ATTACHMENT 3

PROPOSED TECHNICAL SPECIFICATION CHANGES
FOR QUAD-CITIES 1

1.1/2.1 FUEL CLADDING INTEGRITY

FIGURE 2.1-1

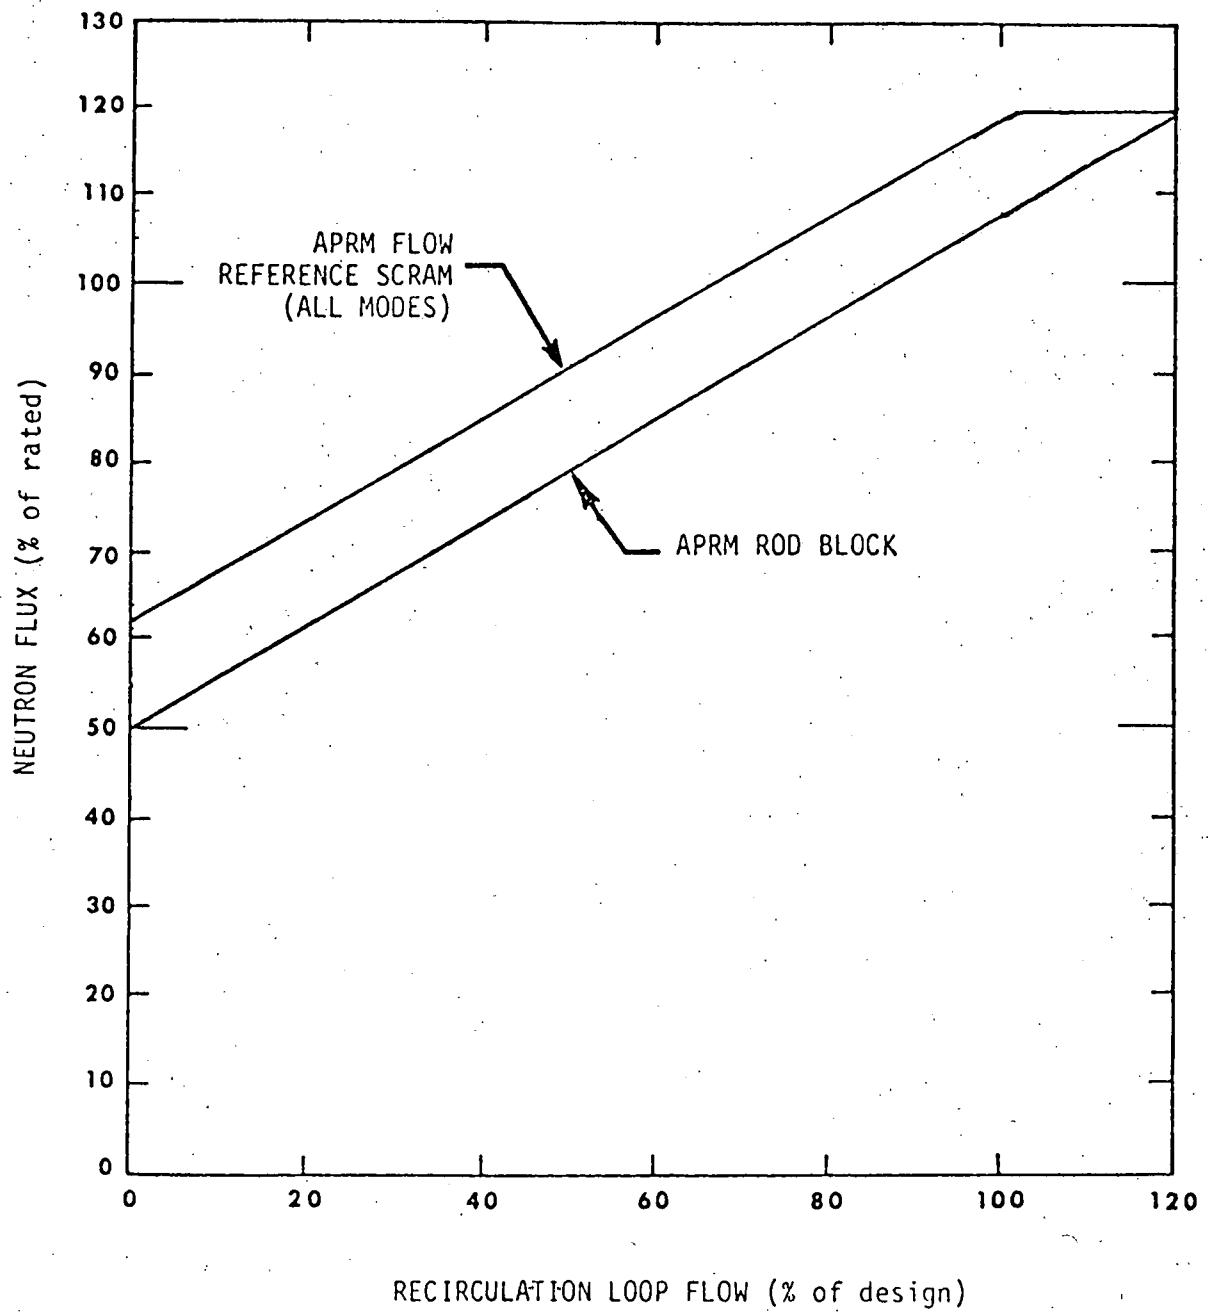
When the reactor mode switch is in the Run position, the APRM flux scram setting shall be as shown in Figure 2.1-1 and shall be:

$$S \leq (58W_D + 62) \quad (LTPF/TPF)$$

with a maximum setpoint of 120% for core flow equal to 98×10^6 lb/hr and greater,

The APRM rod block setting shall be as shown in Figure 2.1-1 and shall be:

$$S \leq (.58W_D + 50) (LTPF/TPF)$$
